ORIGINATION FORM

Proposed Revisions to a Standard Plans Index

Index Number: 700-040
Sheet Number (s): All of 5
Index Title: Cantilever Sign Structure

LAST REVISION	11/01/17	DESCRIPTION:	11/01/22		FY 2022-23 STANDARD PLANS	CANTILEVER SIGN STRUCTURE	INDEX 700-040	SHEET 1 of 5
---------------	----------	--------------	----------	--	------------------------------	---------------------------	------------------	-----------------

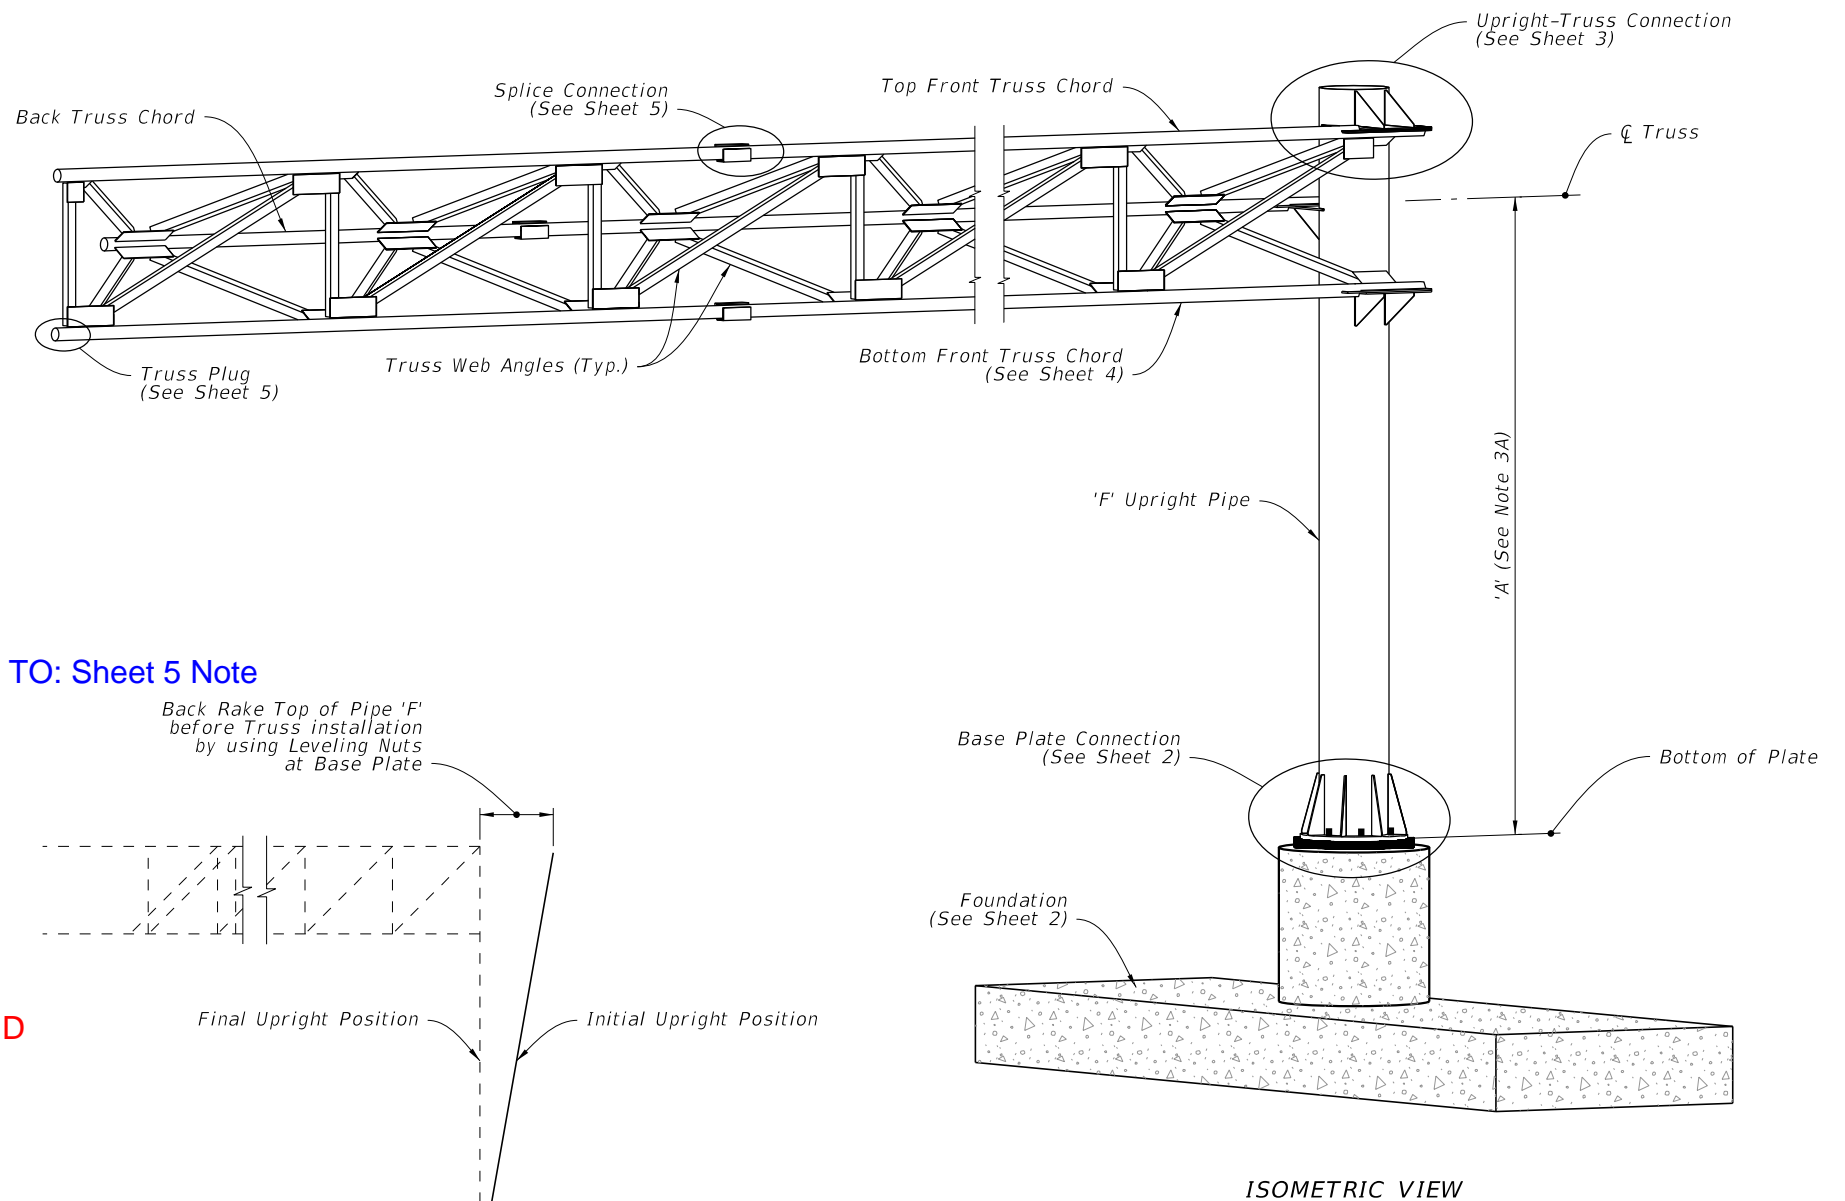
- Sheet 1: Updated Notes to General Notes; Added New General Note 1 - "Meet the requirements of Specification 700."; Deleted Notes 4 through 7; Moved Note 5.B to Sheet 5 Notes; Renumbered Notes.

UPDATED: GENERAL NOTES:

ADDED NEW NOTE 1: Meet the requirements of Specification 700.

DELETED

MOVED TO: Sheet 5 Note

DELETED

GENERAL COMMENT: Some material, construction, and fabrication information was deleted. Information is either already covered in Standard Specifications OR will be added to Section 700, 962 or 965 in conjunction with these revisions.

LAST REVISION	DESCRIPTION:
11/01/21	11/01/22

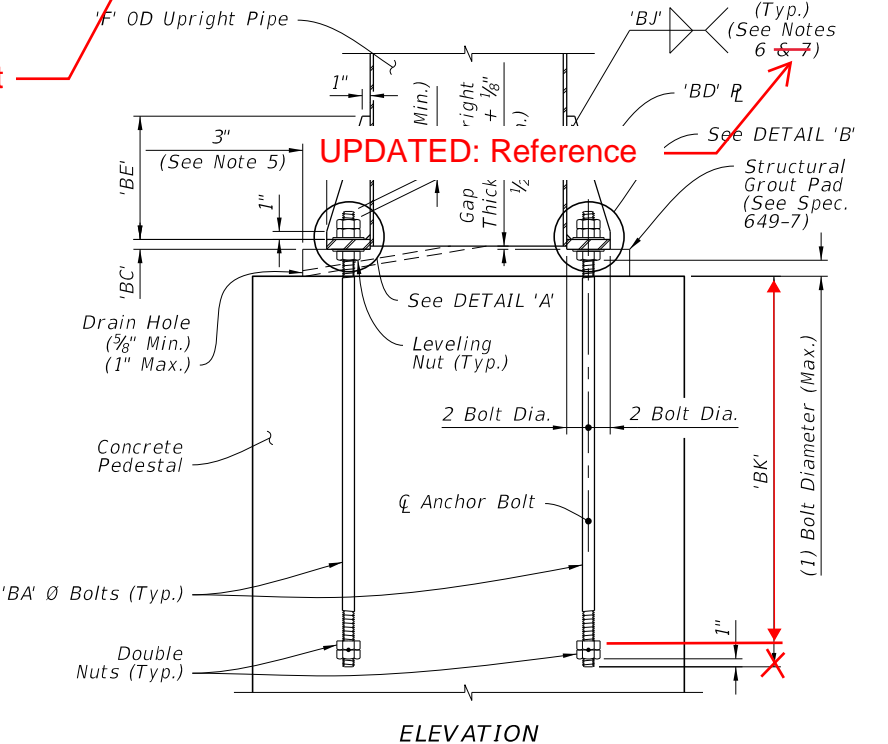
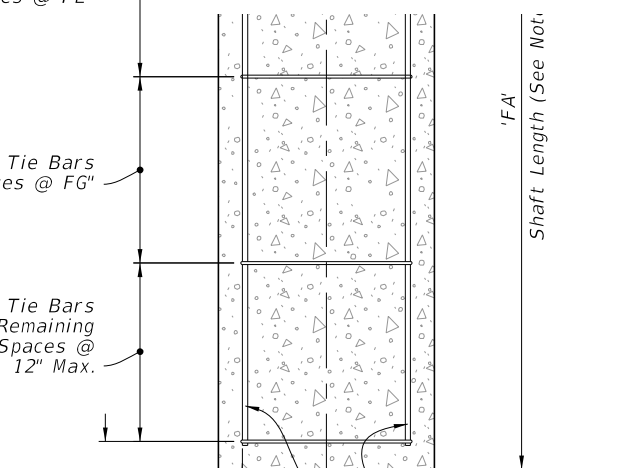
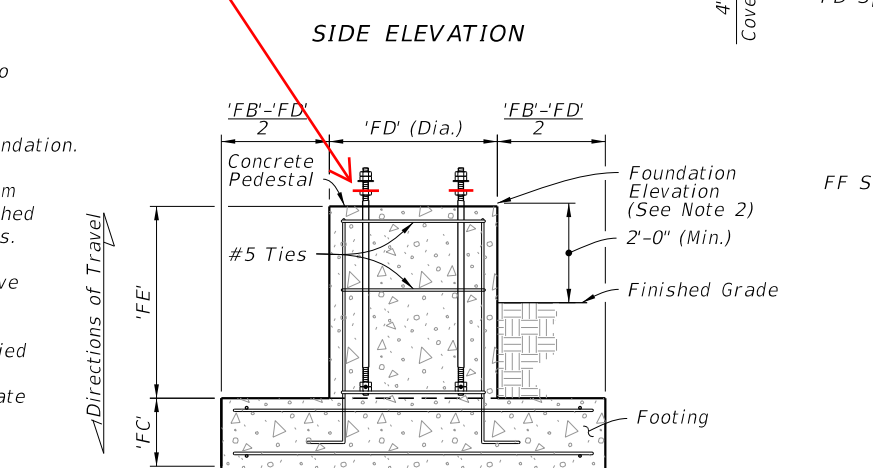
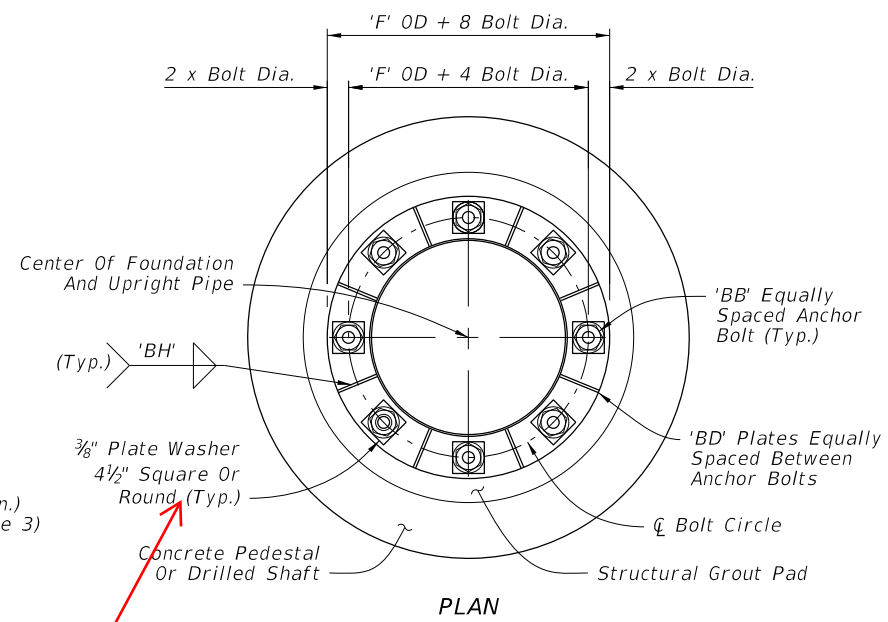
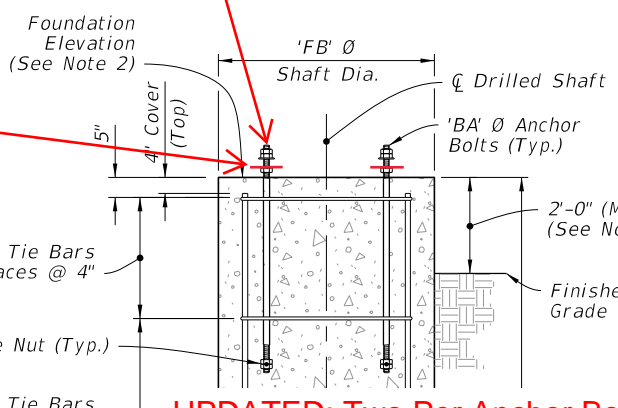
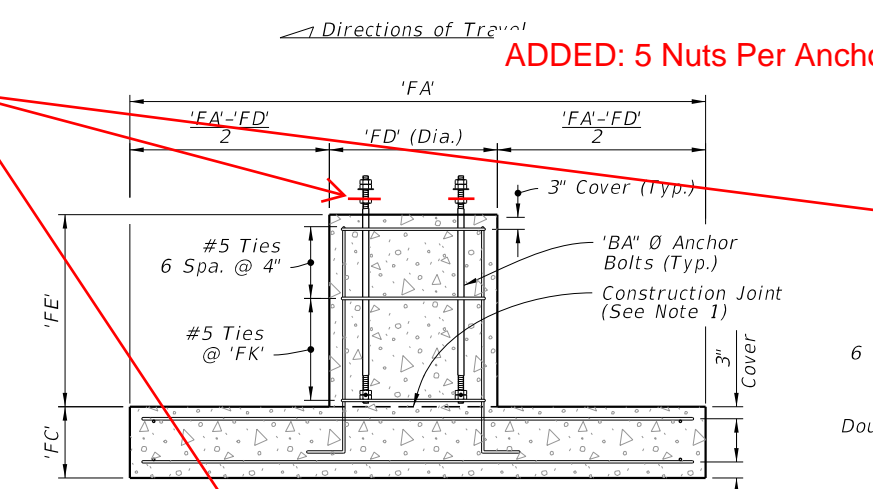
- Sheet 2: Deleted Note 7 ; Added Plate Washers to the Anchor Bolts and new callout "5 Nuts Per Anchor Bolt (Typ.)"; in the FOUNDATION details; Updated the Plate Washer callout and the weld references in the BASE PLATE CONNECTION details; Added new note detailing the weld pattern of the 'BD' plates indicating that they should be welded in a star pattern; Changed dimension 'BK' extents in Base Plate Connection detail to match calculations.

Sheet 2: New Note - This process is to help prevent residual stress buildup in base plate connection to prevent cracking.

DELETED

ADDED: 5 Nuts Per Anchor Bolt (Typ.)

UPDATED: Two Per Anchor Bolt

UPDATED: Reference

- Wrap fillet weld around the stiffener termination on the tube wall.
 - Weld plates 'BD' in a star pattern. A star pattern is one in which the plates on opposite and near opposite sides of the pole circle are successively welded in a pattern resembling a star. For an 8 plate circle with plates sequentially numbered 1 to 8, weld the plates in the following order: (1, 5, 7, 3, 8, 4, 6, 2).

SECTION A-A

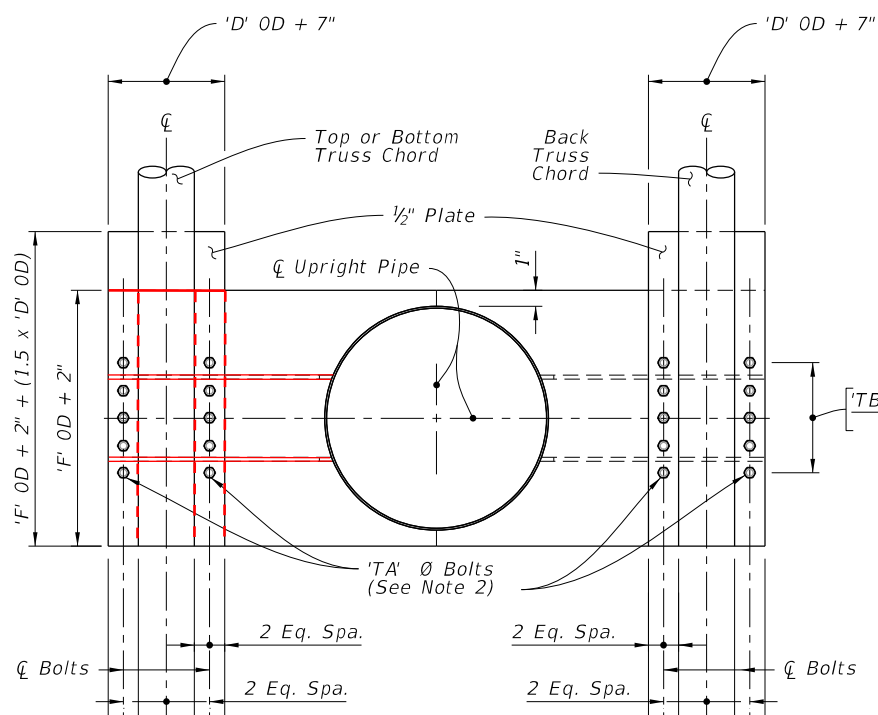
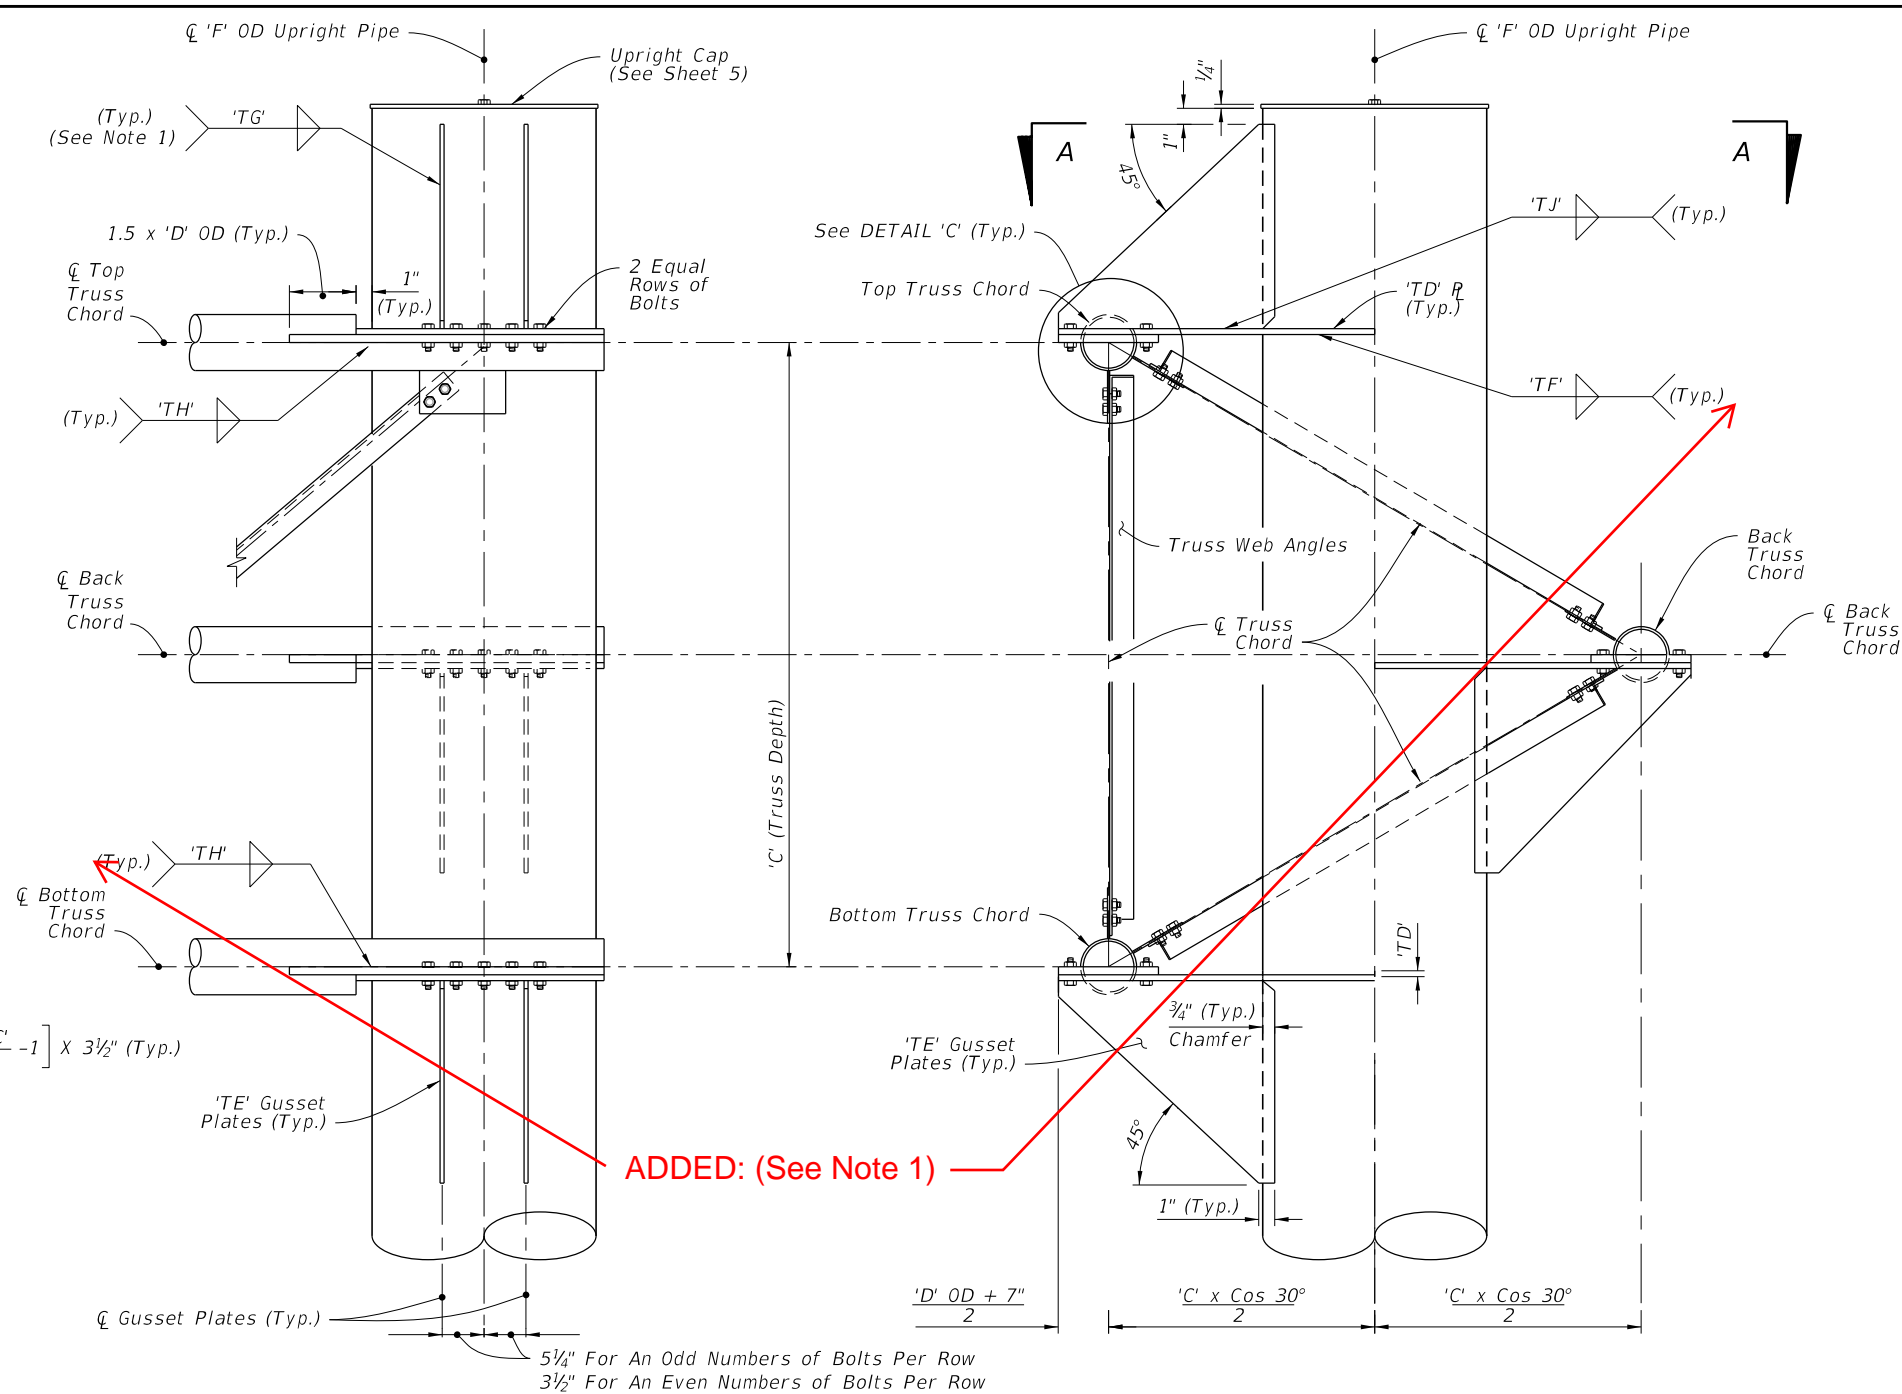
- Sheet 3: Updated line work on Section A-A to correctly reflect correct geometry; Added (See Sheet 1) to the 'TH' and the 'TF' welds.
- Sheet 4: Corrected reference in Detail F.

Sheet 3: Updated for errors and clarity

SPLICE CONNECTION DETAIL

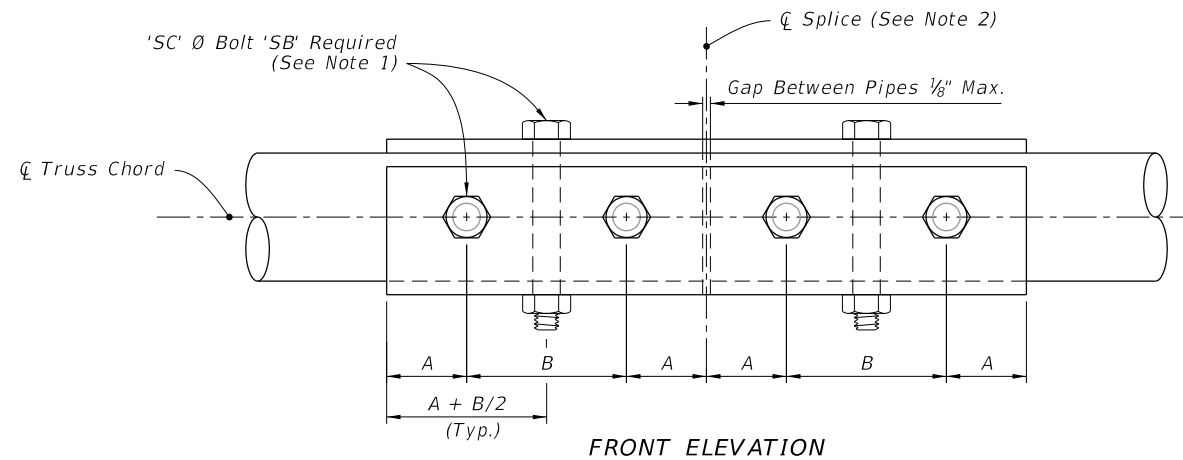
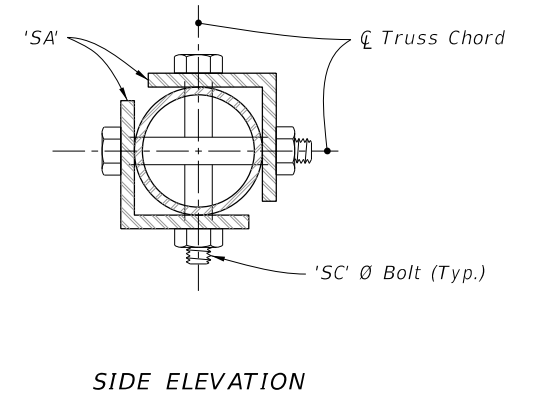
- Sheet 5: Added General Note 5.B as New Note 3 - "Chord Splices: "SD" Panel from upright is the closest panel in which chord splice may be used. See Plans for CANTILEVER SIGN STRUCTURE DATA TABLE. Minimum splice spacing is two truss panel lengths apart."

ADDED NOTE 3:
 Chord Splices: "SD" Panel from upright is the closest panel in which chord splice may be used. See Plans for CANTILEVER SIGN STRUCTURE DATA TABLE. Minimum splice spacing is two truss panel lengths apart

1. Only 6 bolts are shown in detail for clarity. (One Half Each Side Of Splice)
2. Splices are not permitted for trusses less than or equal to 40', Splice optional for trusses greater than 40'.
3. Chord Splices: "SD" Panel from upright is the closest panel in which a chord splice may be used. See Plans for CANTILEVER SIGN STRUCTURE DATA TABLE. Minimum splice spacing is two truss panel lengths apart.
